ADDENDUM NO. 5

RE: COVID Center – Lafayette County, Arkansas

ADDENDUM DATE: May 23, 2022

MECHANICAL PLAN

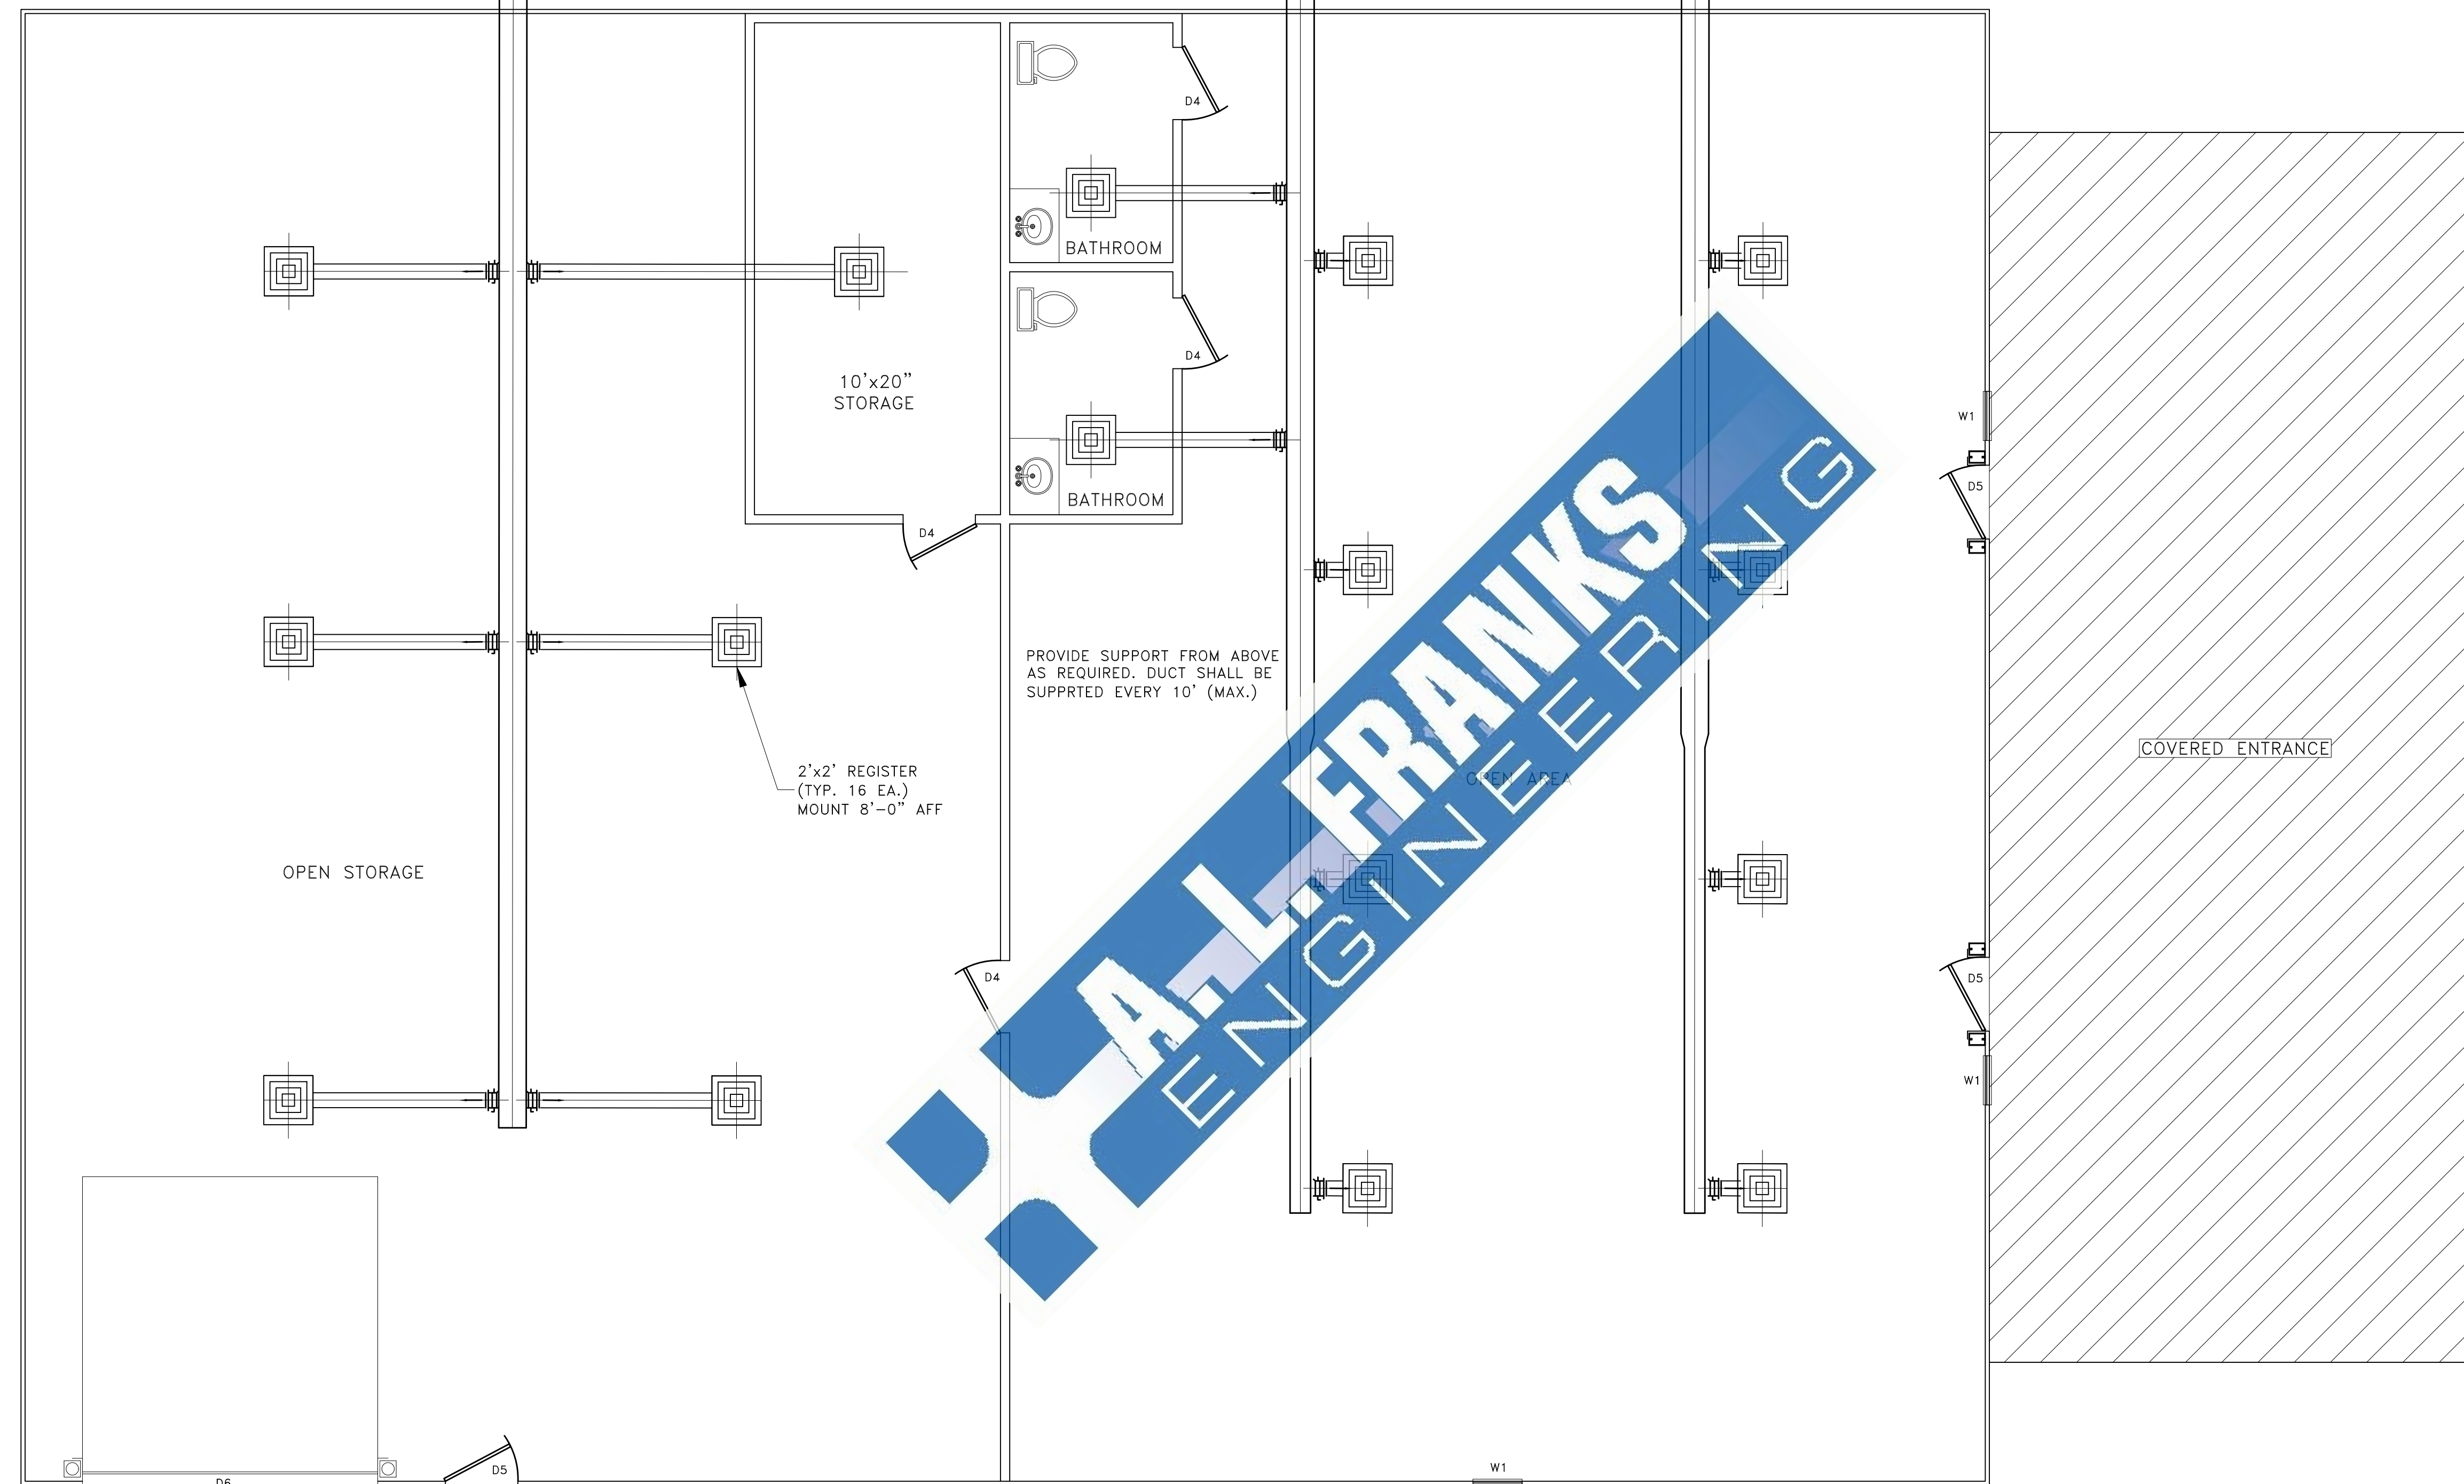
1. **Sheet 7: Water heater to be modified to a 50 gallon gas water heater instead of electric. Manufacturer to remain as Whirlpool.**
2. **Sheet 8: Sheet 8 to be replaced with attached revision. HVAC units modified to use gas heat and 3 separate 5 ton units to be provided as shown or approved equal.**

CU-1-SHALL BE MOUNTED ON A 4" CONCRETE PAD RHEEM - MOD#RGECR060AJT12 5 TON SINGLE STAGE W/GAS HEAT OR APPROVED EQUAL

Date	Revision	By
5-23-22	1-HVAC UNIT AND DUCT SYSTEM REVISED	CJM
